Below is the list of 13 variances required as listed in staff memo for zba hearing on 15 dec 2021. Revisions to the proposed design make 6 of the variances no longer required. The 6 variances that are no longer required are shown with a strikethrough.

V6 -
HABITABLE SPACE
DEPTH

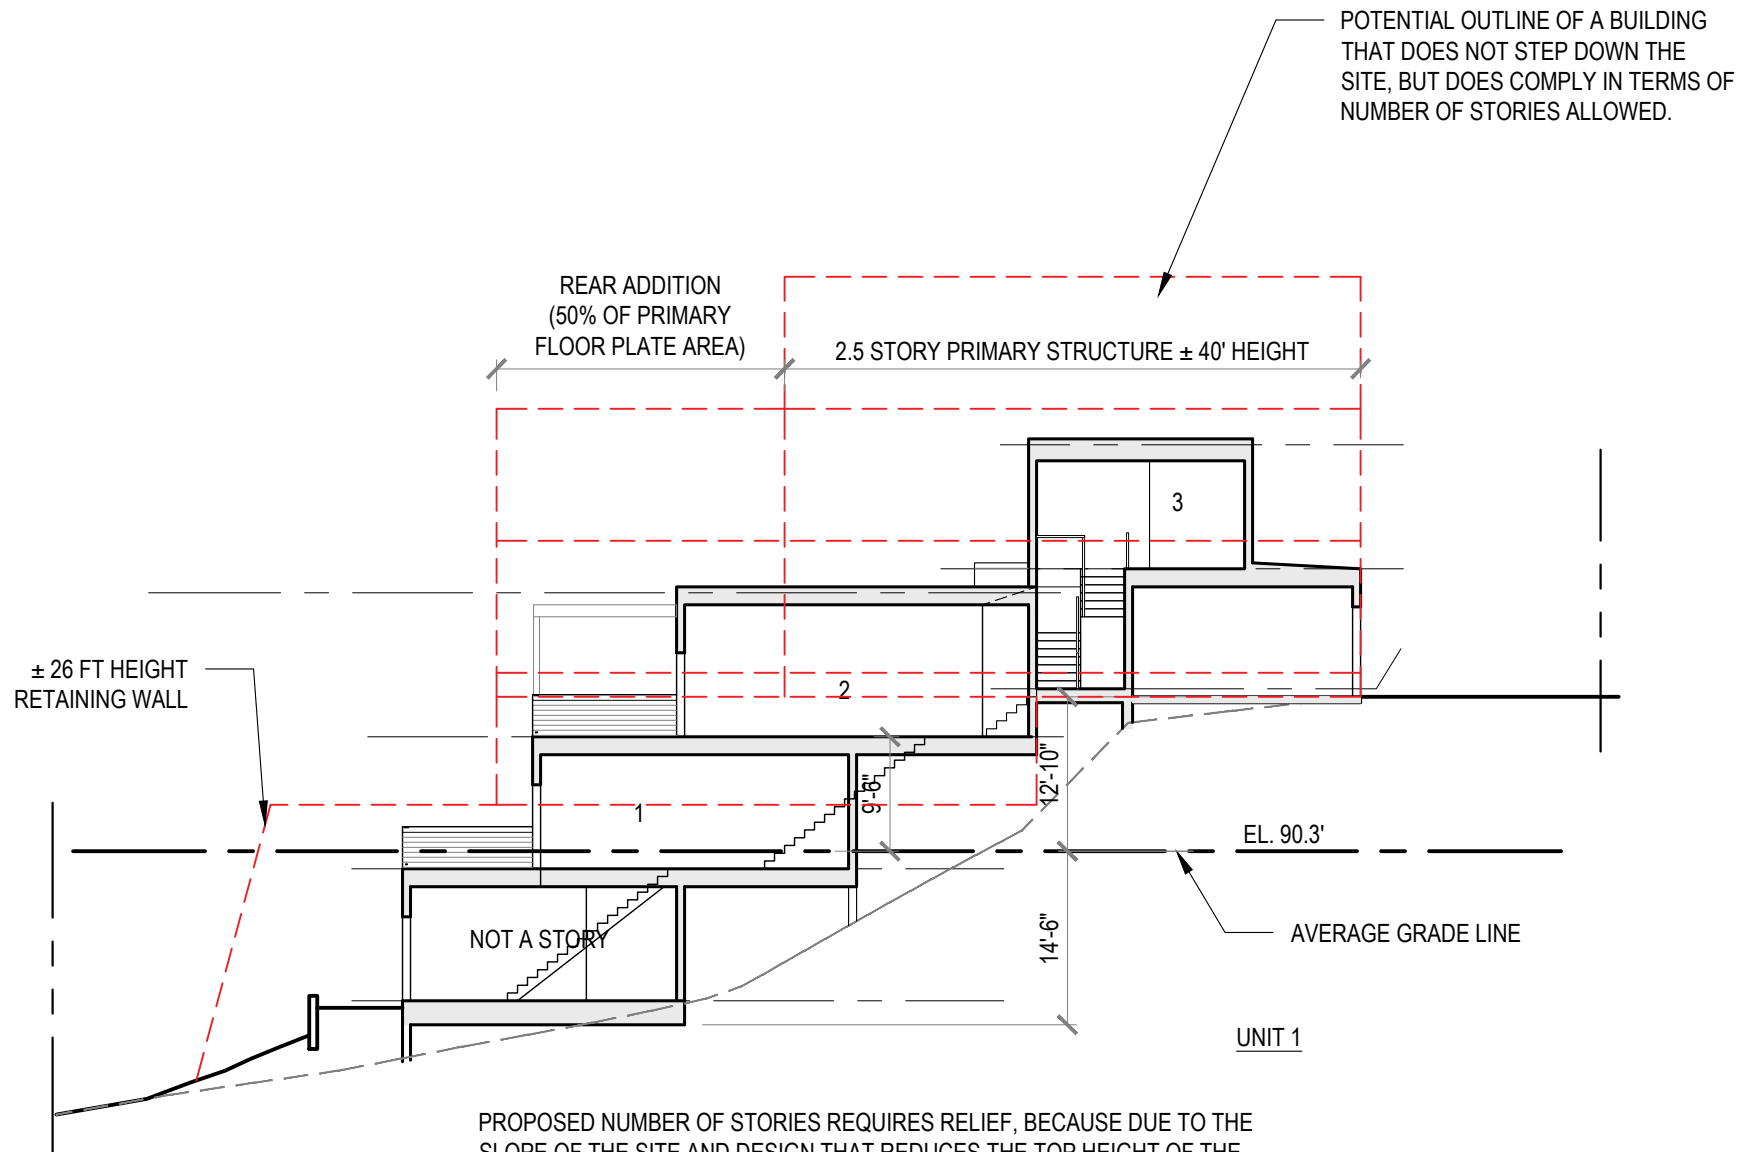
HABITABLE SPACE DEPTH REQUIRES RELIEF, BECAUSE THE DESIGN PLACES THE MAIN LIVING STORY BELOW THE GRADE AT THE FACADE IN ORDER TO LOWER THE TOP HEIGHT OF THE BUILDING

REQUIRES RELIEF

V7a - NUMBER OF STORIES

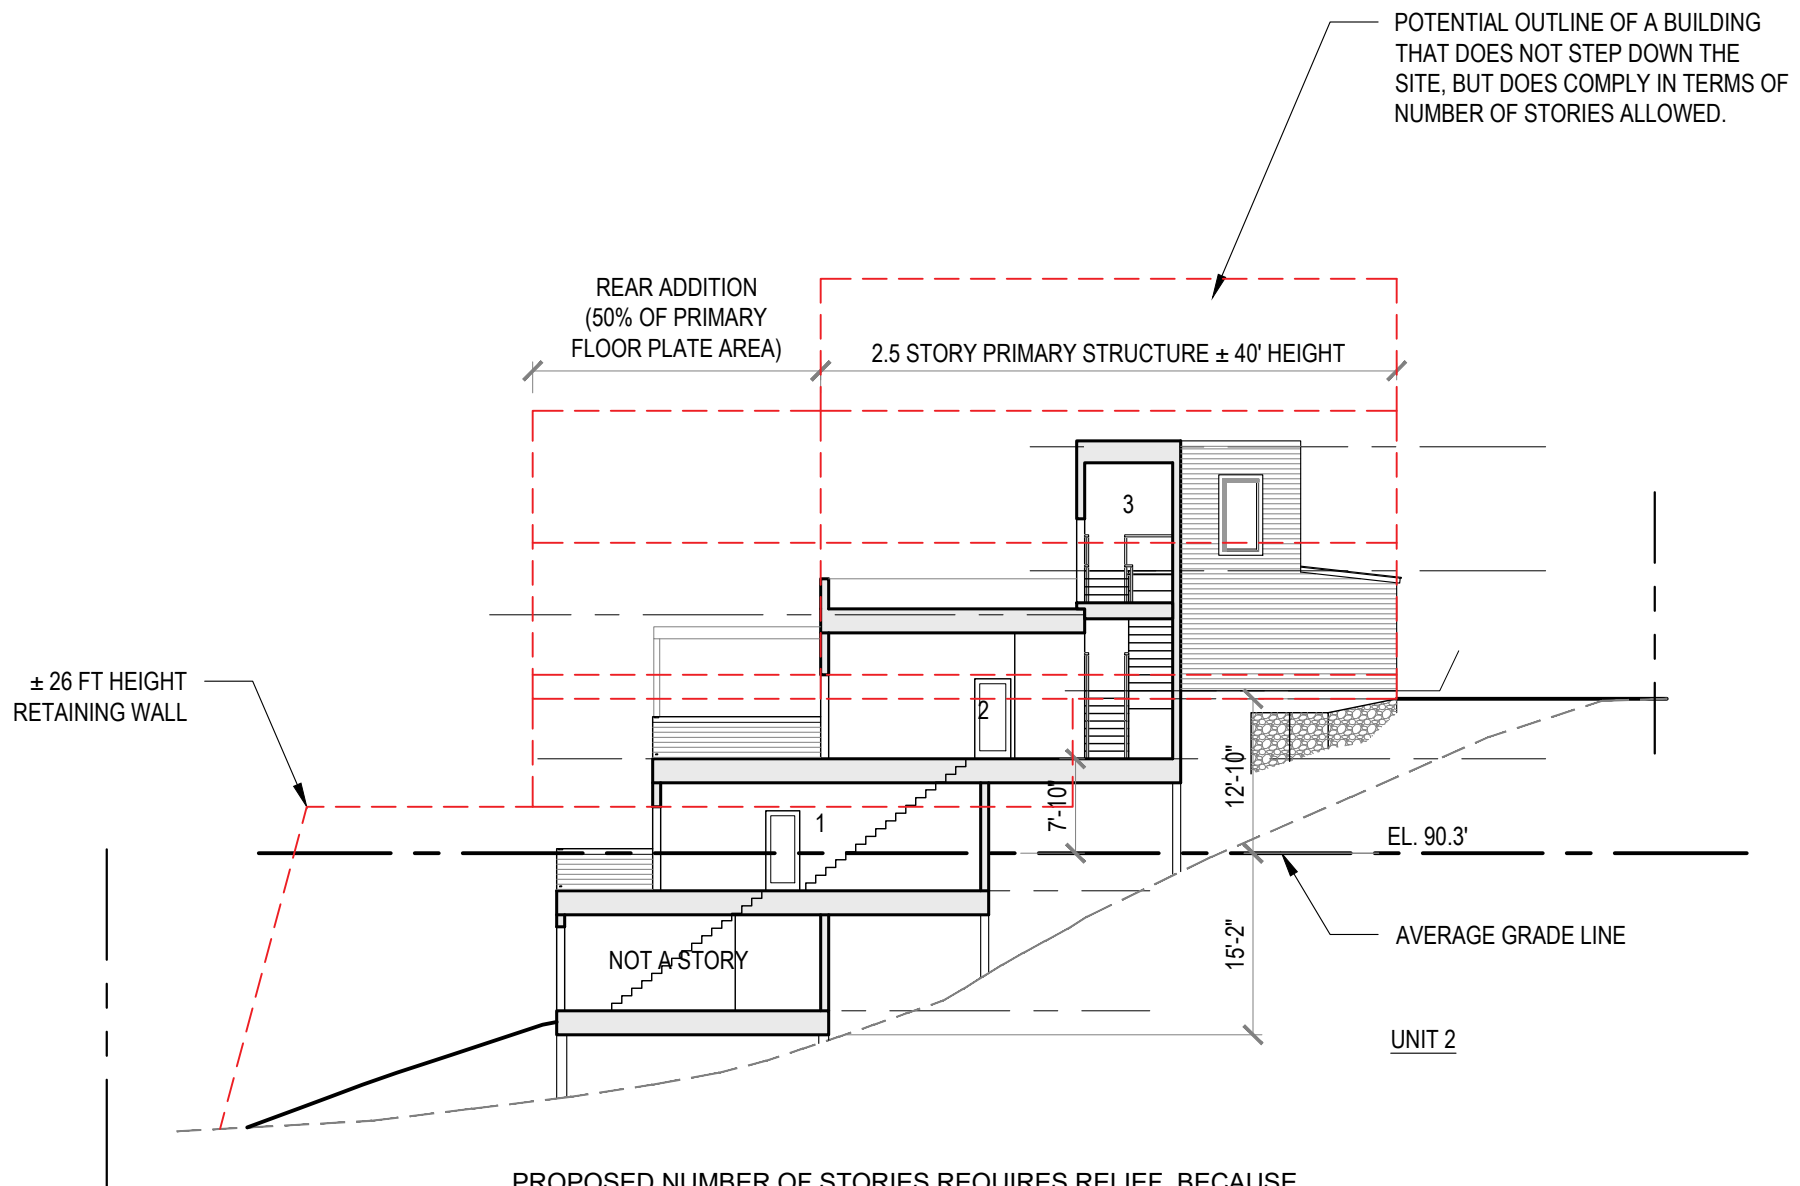
PROPOSED NUMBER OF STORIES REQUIRES RELIEF, BECAUSE DUE TO THE SLOPE OF THE SITE AND DESIGN THAT REDUCES THE TOP HEIGHT OF THE BUILDING, THE PROPOSAL STEPS DOWN THE SITE. DOING SO CREATES 3 STORIES PLUS 1 NON-STORY BECAUSE OF THE UNIQUE STEEPNESS OF THE SITE. THE MASTER SUITE LEVEL IS CONSIDERED A STORY, BECAUSE THE FLOOR ABOVE IT 5' OR MORE ABOVE AVERAGE GRADE LEVEL. AVERAGE GRADE ON SUCH A STEEP SITE IS FAR BELOW AVERAGE GRADE LEVEL OF A TYPICAL SITE.

SOUTH ELEVATION
OF UNIT 1
REQUIRES RELIEF

V7b - NUMBER OF STORIES

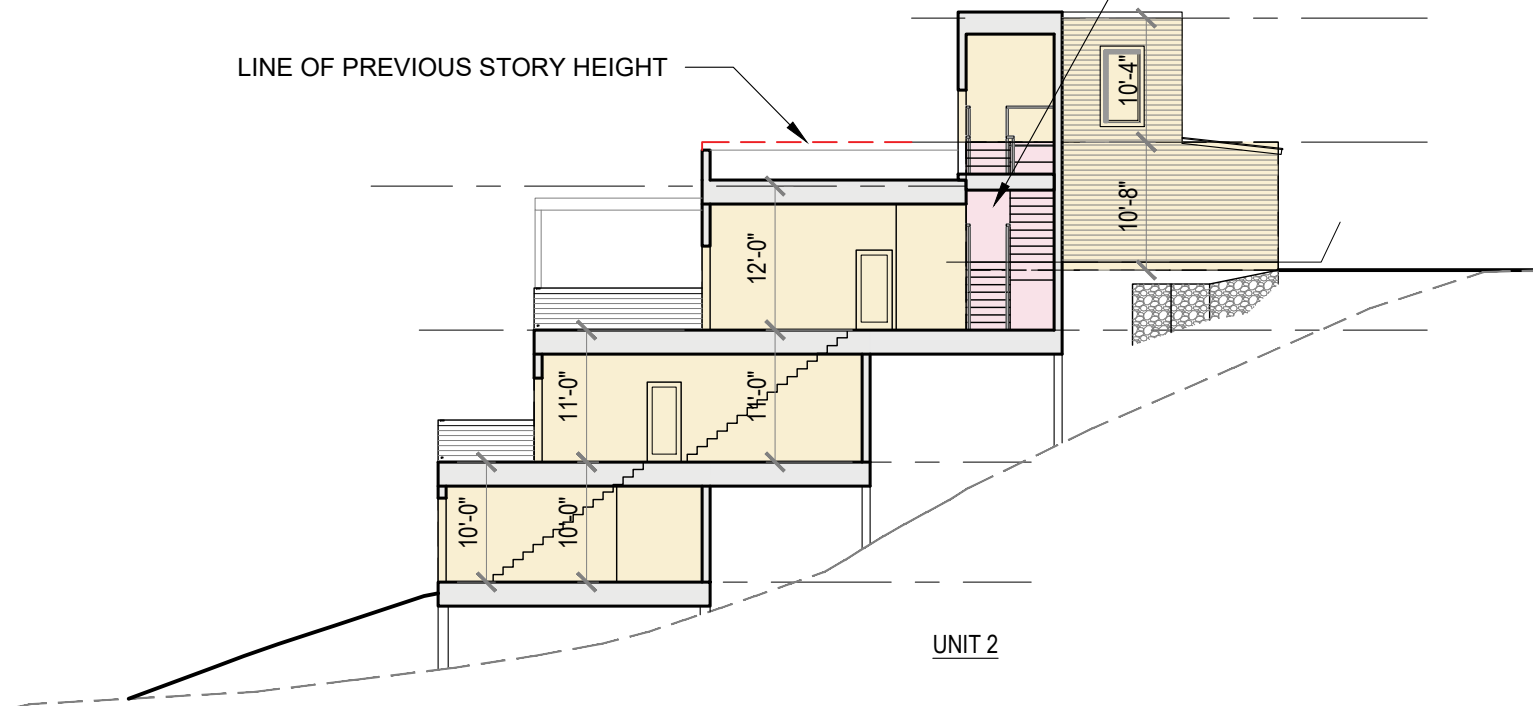
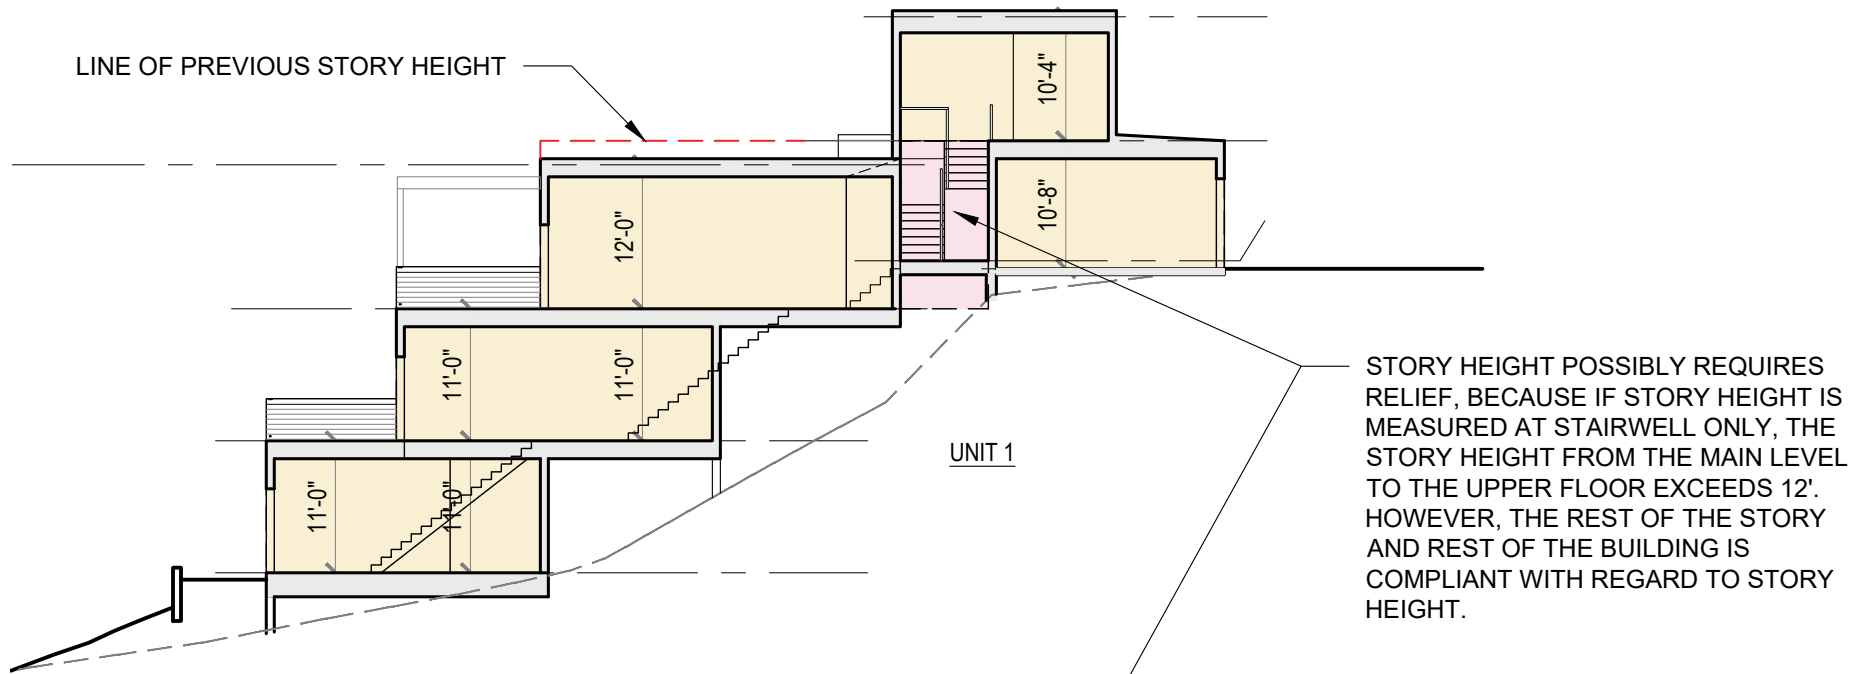
PROPOSED NUMBER OF STORIES REQUIRES RELIEF, BECAUSE DUE TO THE SLOPE OF THE SITE AND DESIGN THAT REDUCES THE TOP HEIGHT OF THE BUILDING, THE PROPOSAL STEPS DOWN THE SITE. DOING SO CREATES 3 STORIES PLUS 1 NON-STORY BECAUSE OF THE UNIQUE STEEPNESS OF THE SITE. THE MASTER SUITE LEVEL IS CONSIDERED A STORY, BECAUSE THE FLOOR ABOVE IT 5' OR MORE ABOVE AVERAGE GRADE LEVEL. AVERAGE GRADE ON SUCH A STEEP SITE IS FAR BELOW AVERAGE GRADE LEVEL OF A TYPICAL SITE.

SOUTH ELEVATION
OF UNIT 2
REQUIRES RELIEF

V8 -
STORY HEIGHT

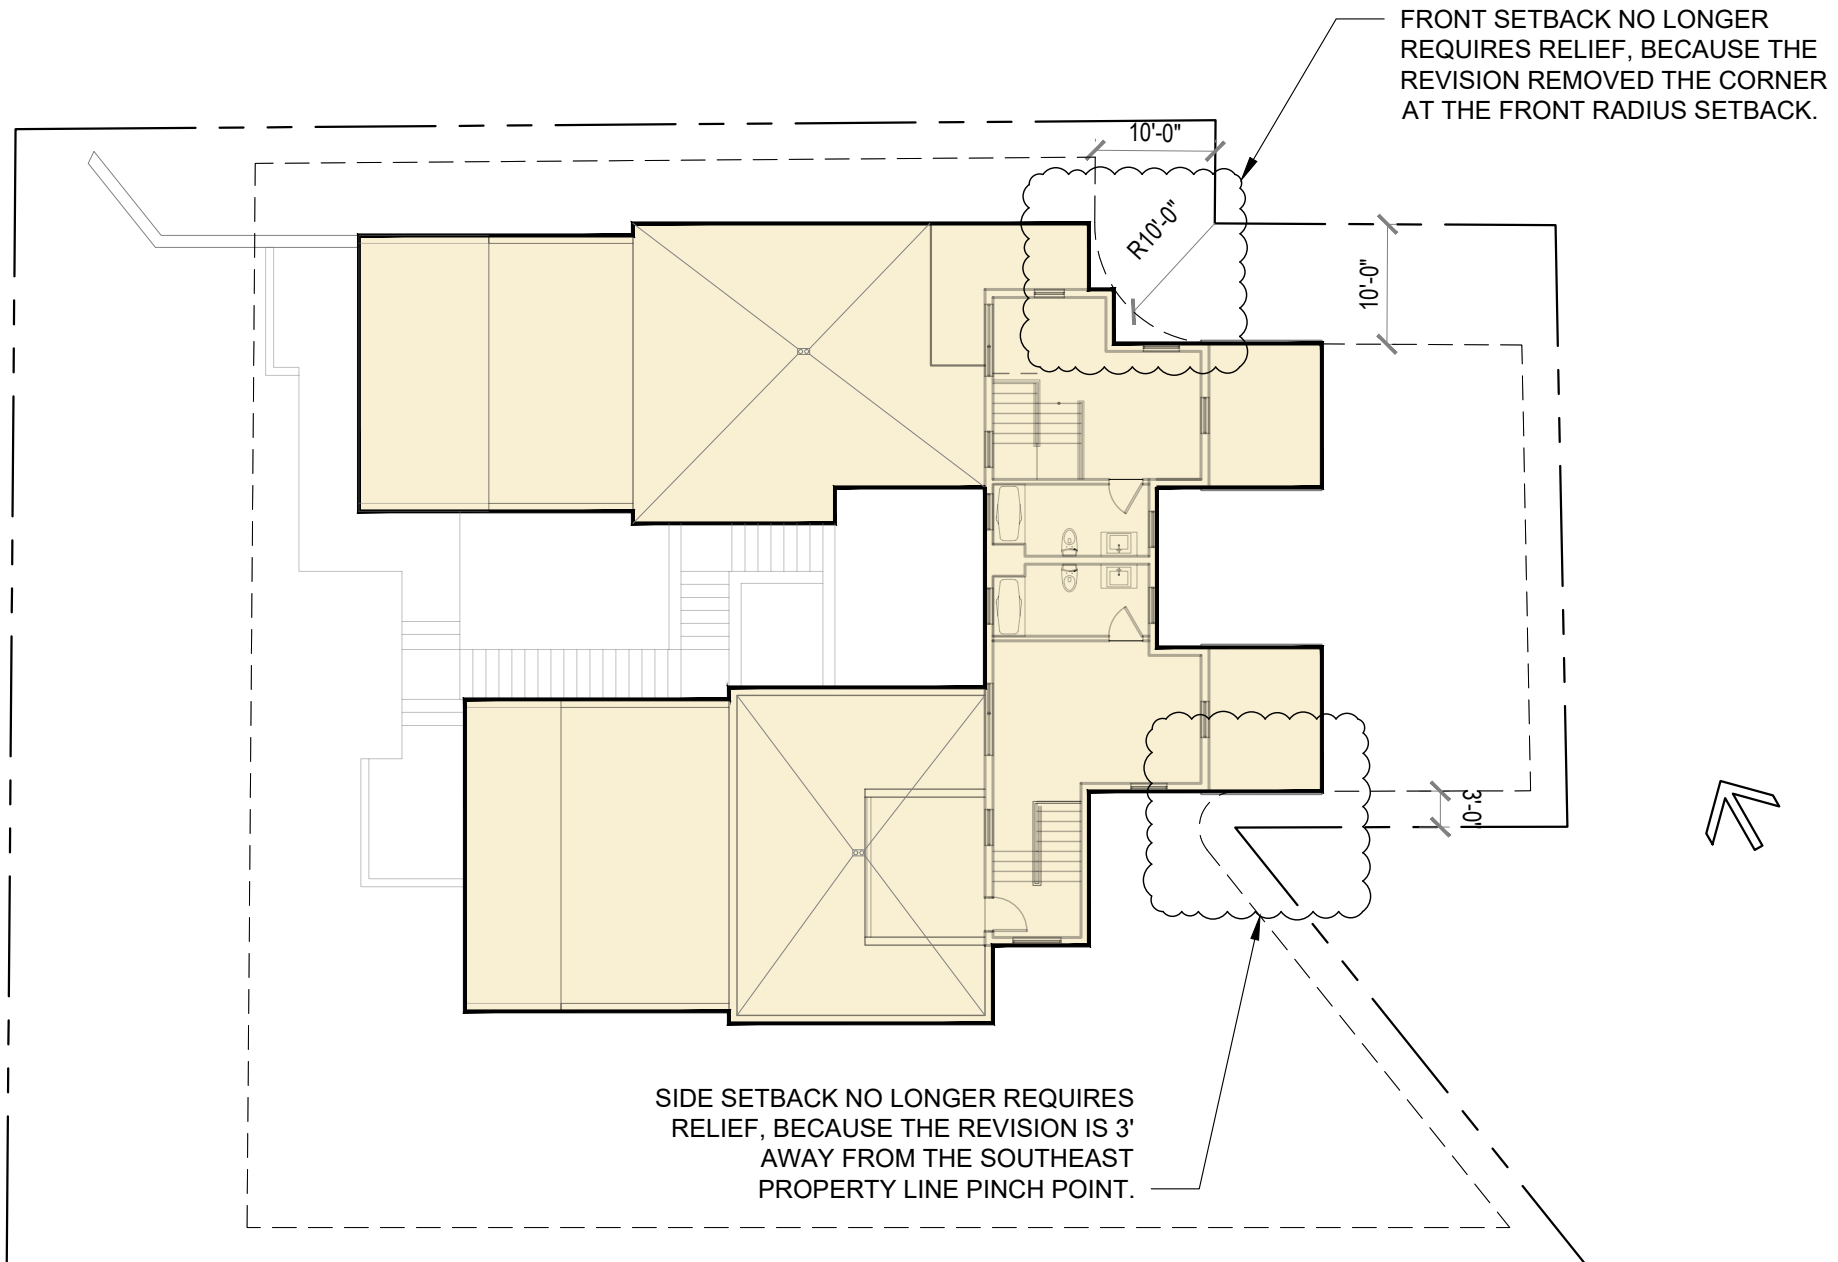
REQUIRES RELIEF

V9 FRONT SETBACK
AND V10 SIDE
SETBACK

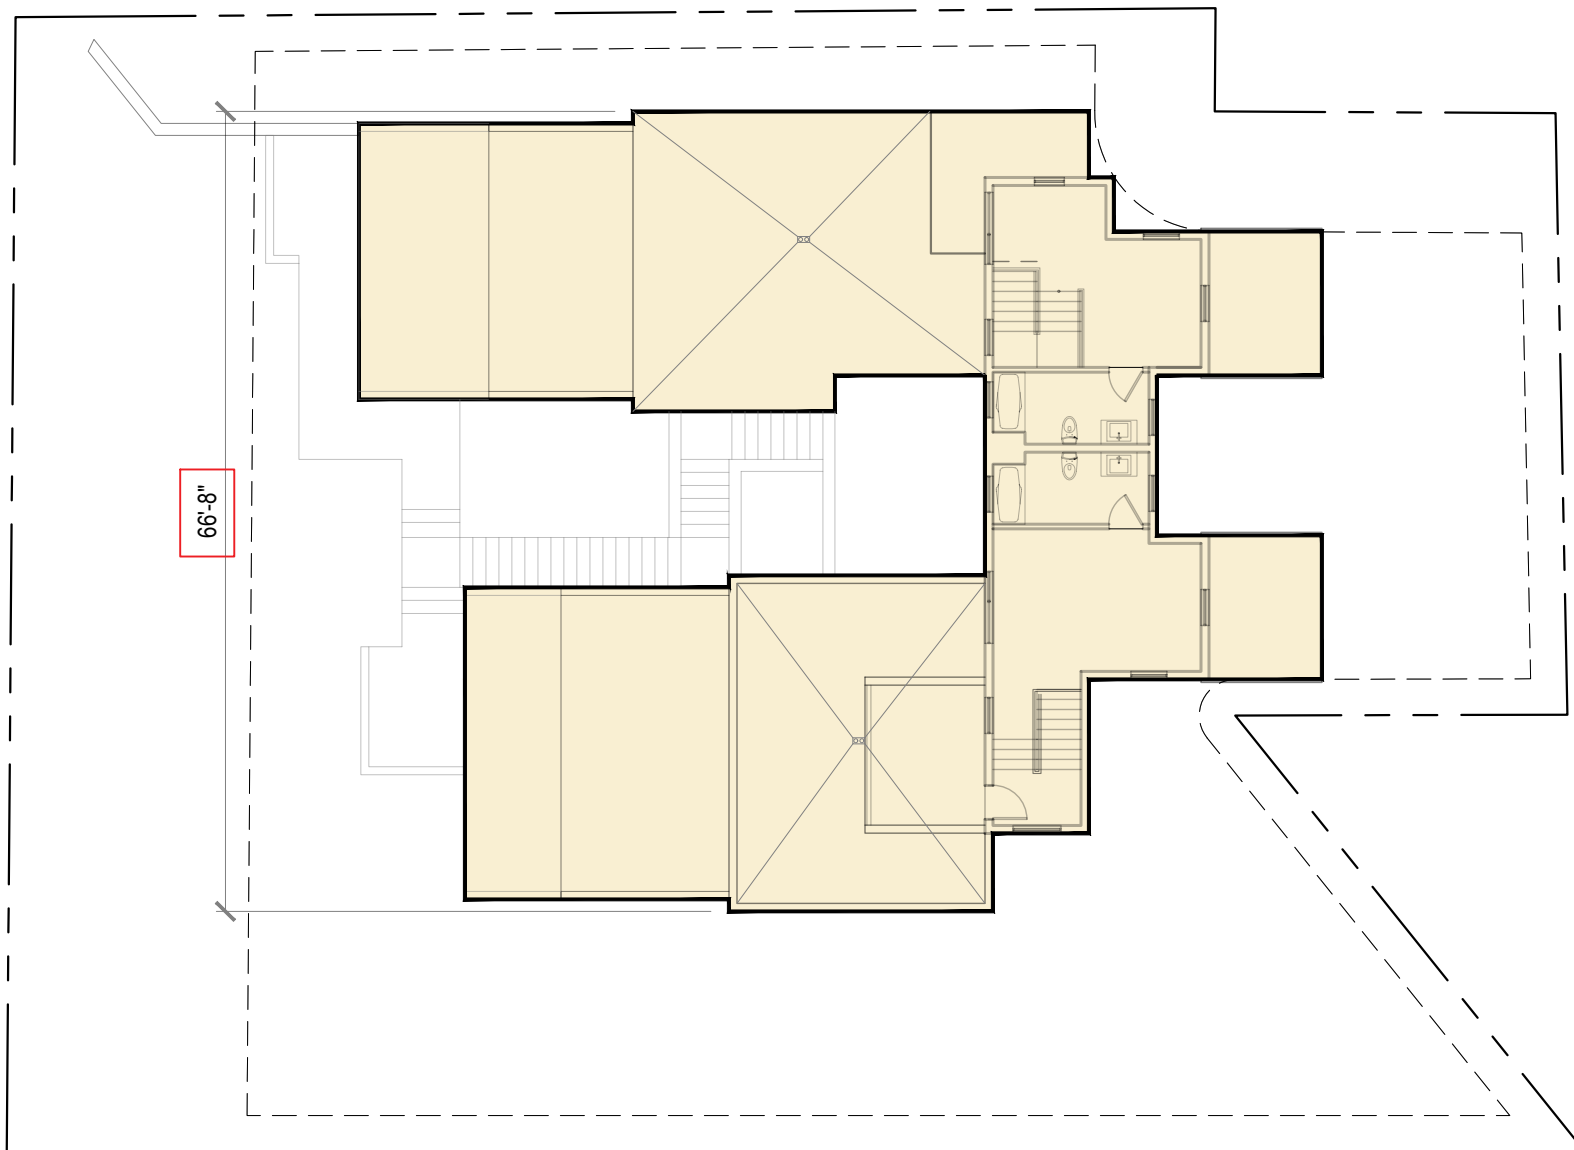
NO LONGER
REQUIRE RELIEF
